A RALLYE

N° 120

CR 27-13

SUBJECT : Location of the rudder control on the rudder pedals.
Replacement of the rod nut by a guide nut.

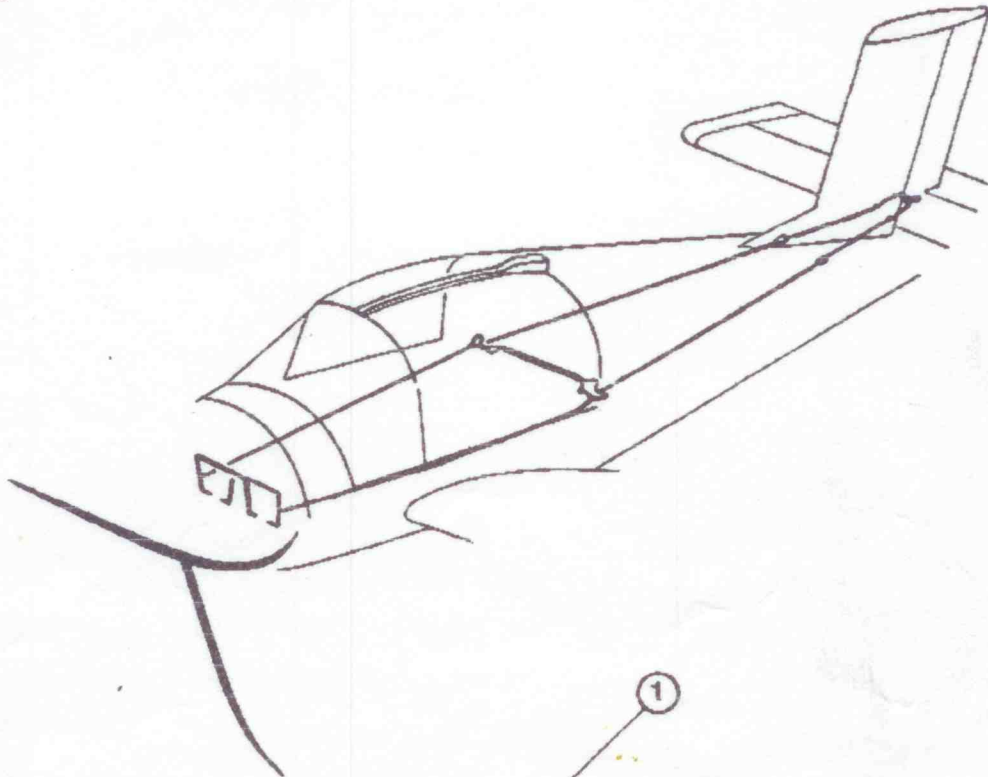
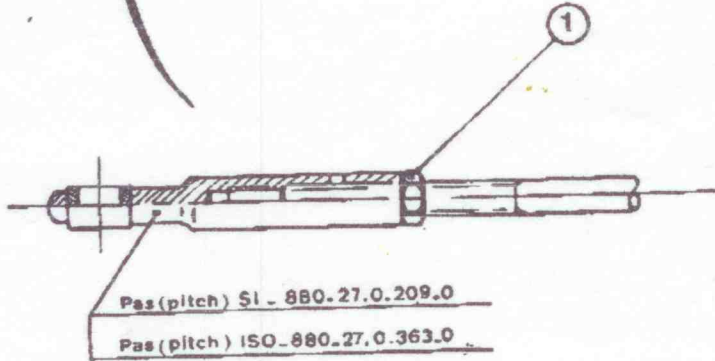
On the other hand, at the time of overhaul or maintenance operations, some unusual manoeuvres can create abnormal buckling stresses on the rods (for example : the manoeuvre which would consist in pulling one rudder pedal while the other is maintained unmoved). This buckling may, in borderline cases, cause the failure of the rod in its threaded area, behind the eye bolt which ensures the attachment with the rudder pedal. A few similar incidents having occur, we have provided a safety device which consists in replacing the nut, item 1, by a guide nut, item 2. (see figure on page 2/3). This guide nut which has an important length and is bored at its ends, forms a bushing which is engaged both on the eye bolt tail (previously undercut) and on the plain length of the rod. This prevents any bending in this area.

1°/ For the rods with "SI" pitch - up to n° 2453 (light airframes) and n°12453 (heavy airframes).

2°/ For the rods with "ISO" pitch - from n° 2454 (light airframes) and n°12454 (heavy airframes).

Remove the old eye bolt n° 880.27.0.209.0 and the nut item 1.

Install the undercut eye bolt n° 880.27.0.404.0 and the guide nut n° 880.16.0.059.0

Remove the old eye bolt n° 880-27.0.363.0 and the nut item 1.

Install the undercut eye bolt n° 880-27.0.402.0 and the guide nut n° 880-16.0.185.0.
